Access Compliance Report

Public Rights-of-Way

Intersection ID: 42578	Main Street: PEACEFUL WAY DR	Cross Street: STROUD PARK CT	Location: NW
ADA ID: 55760EA4DE70	Ramp Type: PerpDiag	Initial Pass/Fail: Fail	Overall Compliance: No
		Severity Score: 17.5

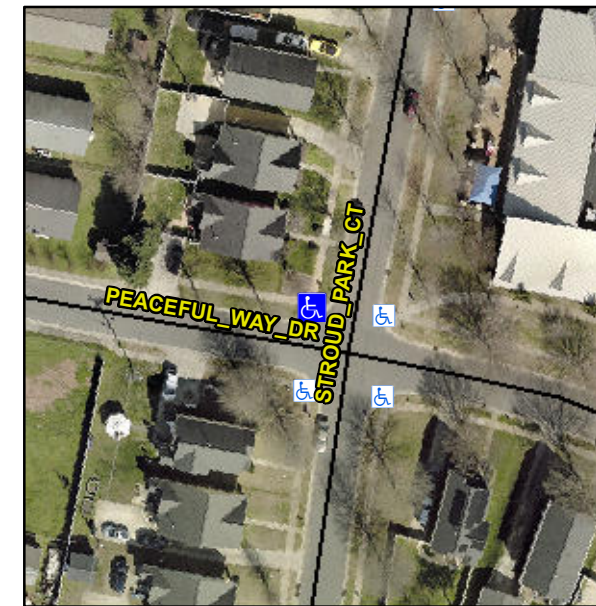
Not Found, R304.5.1

Compliance	Description	Data	Compliance	Description	Data
N/A	Ramp Length (in)	94.0	Yes	Ramp Slope (%)	6.0
No	Ramp Width (in)	32.5	Yes	Ramp XSlope (%)	1.8
N/A	Flare Type LT	N/A	N/A	Flare Type RT	N/A
N/A	Flare Slope LT (%)	N/A	N/A	Flare Slope RT (%)	N/A
N/A	Flare Traversable LT?	N/A	N/A	Flare Traversable RT?	N/A
N/A	Landing Length (in)	N/A	N/A	DWS Provided?	N/A
N/A	Landing Width (in)	N/A	N/A	DWS Contrast?	N/A
N/A	Landing Slope (%)	N/A	N/A	DWS Length (in)	N/A
N/A	Landing X Slope (%)	N/A	N/A	DWS Full Width?	N/A
N/A	Landing Curb? (Y/N)	N/A	N/A	DWS Offset (in)	N/A
N/A	Shared Landing?	N/A			
N/A	Gutter Ponding?	N/A	N/A	Gutter Slope (%)	N/A
N/A	Gutter Lip Ht (in)	1.5	N/A	Gutter X Slope (%)	N/A
N/A	Painted X Walk1?	No	N/A	Painted X Walk2?	No
	X Walk 1 Direction	To NE		X Walk 2 Direction	To NE
N/A	X Walk 1 Width (in)	N/A	N/A	X Walk 2 Width (in)	N/A
	X Walk 1 Slope (%)	2.3		X Walk 2 Slope (%)	0.8
	X Walk 1 X Slope (%)	6.7		X Walk 2 X Slope (%)	0.7

Remove & Replace Curb Ramp With Two New Directional Ramps or Equivalent.
